N7001A-01

Modification Recommended Service Note

N7001A InfiniiMax III+ Series 13 GHz Probe Amplifier
Serial Numbers: ALL

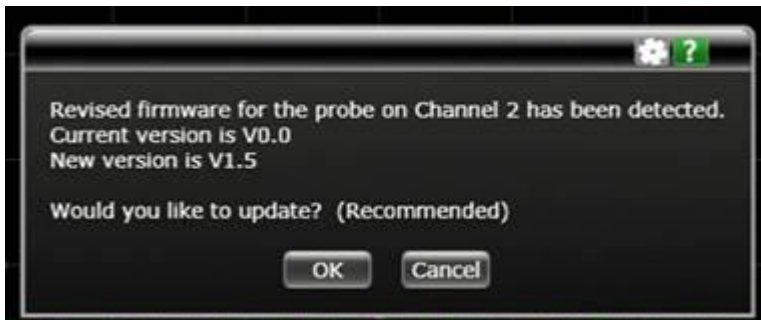
1. Ask the customer if he/she has seen the following message when plugging his/her probe onto an oscilloscope:

2. Regardless of the customer's answer to the question, plug the customer's probe onto a Service Center scope with software version 06.20.00701 or later.
3. If the Customer said No in step 1 or was unsure: tell the customer that Keysight recommends downloading latest scope software version—Version 06.20.00701 or later. Continue with standard procedure.
4. If the Customer said Yes, the probe appears to function normally on the scope, and it passes calibration, the probe has been fixed. Send the original probe back to the customer, and tell the customer that Keysight recommends an upgrade to oscilloscope software—Version 06.20.00701 or later to prevent this issue from re-occurring to their probe.
